# Places Associates, Inc.

Re: Response to Peer Review, VHB dated May 8, 2019  
Special Permit – Green Star Herbals, 24 Main Street, Maynard  
Places Associates' Project No. 5390

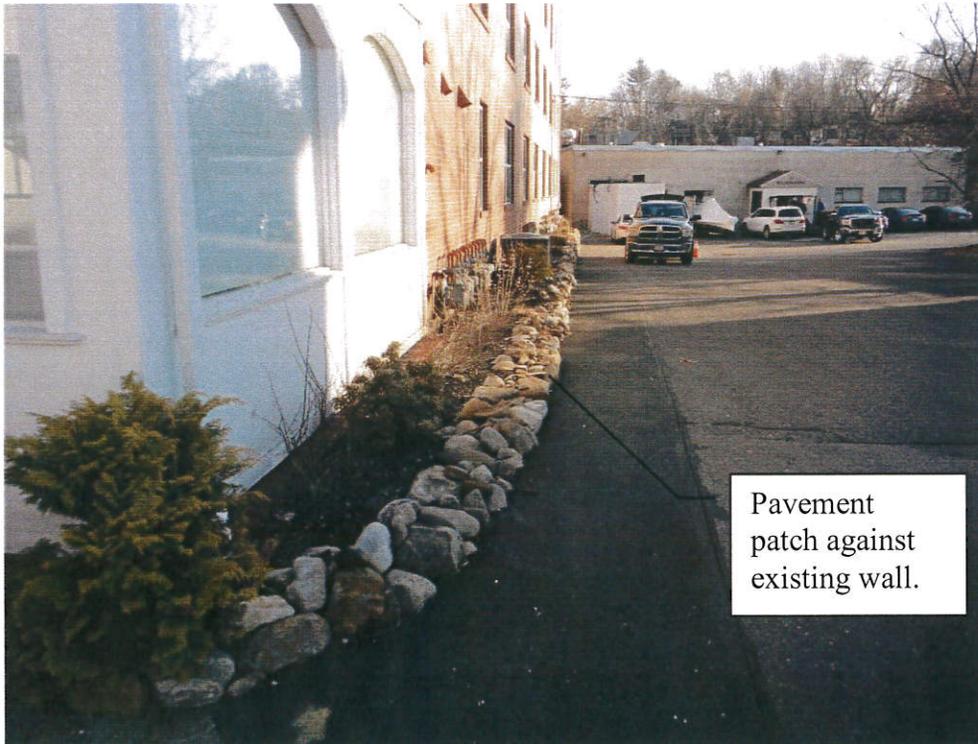
3. Is it possible to maintain existing stone wall and build a sidewalk up against it?  
*See picture attached where the existing pavement was patched up to the edge of the wall. The contractor will be required to install a compacted graded gravel base up to the edge of the wall, supporting those stones in place. As was performed for the pavement patch (gas line?) the asphalt can be placed and compacted in-place to hold the eastern edge of the walk securely.*
